Project	IEEE 802.16 Broadband Wireless Access Working Group <http://ieee802.org/16>	
Title	Adding UCD management message encodings to wman2IfMib	
Date Submitted	2006-09-26	
Source(s)	Joey Chou Intel Corporation	[mailto:joey.chou@intel.com] [mailto:jose.p.puthenkulam@intel.com]

Abstract	This contribution proposes the changes being included to wmanIf2Mib in order to support new capabilities that have been introduced in UCD management message encodings in IEEE 802.16e 2005.
Purpose	Adoption
Notice	This document has been prepared to assist IEEE 802.16. It is offered as a basis for discussion and is not binding on the contributing individual(s) or organization(s). The material in this document is subject to change in form and content after further study. The contributor(s) reserve(s) the right to add, amend or withdraw material contained herein.
Release	The contributor grants a free, irrevocable license to the IEEE to incorporate material contained in this contribution, and any modifications thereof, in the creation of an IEEE Standards publication; to copyright in the IEEE's name any IEEE Standards publication even though it may include portions of this contribution; and at the IEEE's

Figure 23—wman2IfBsPhy Structure

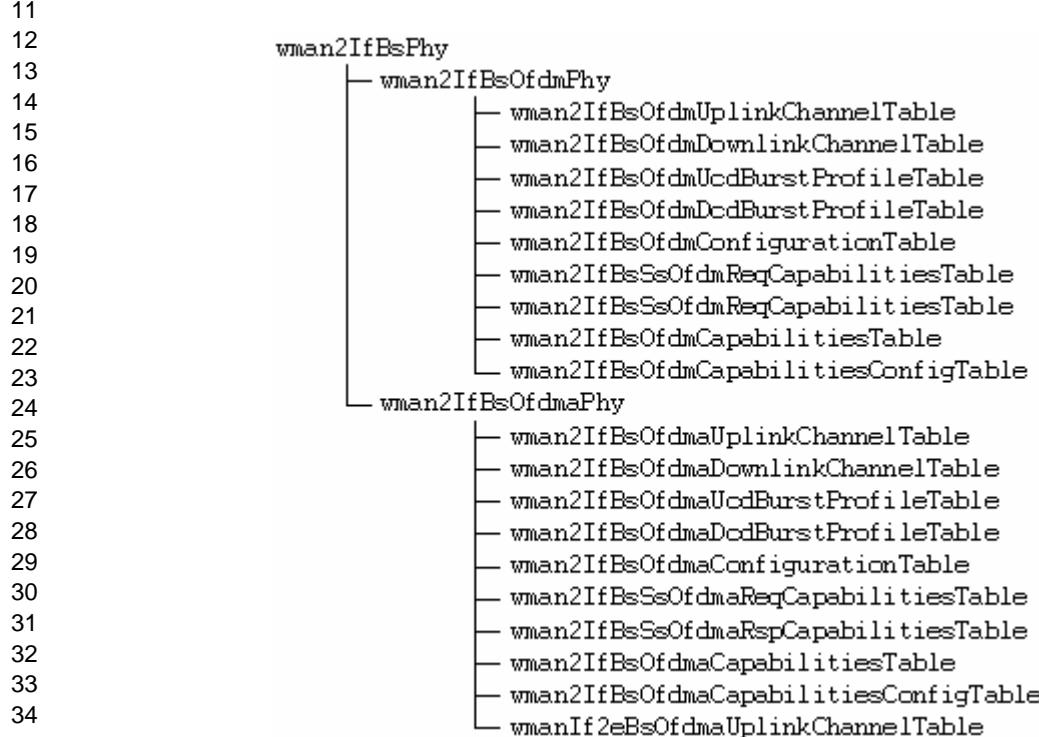
10 [Replace Fig 23 with the following:]
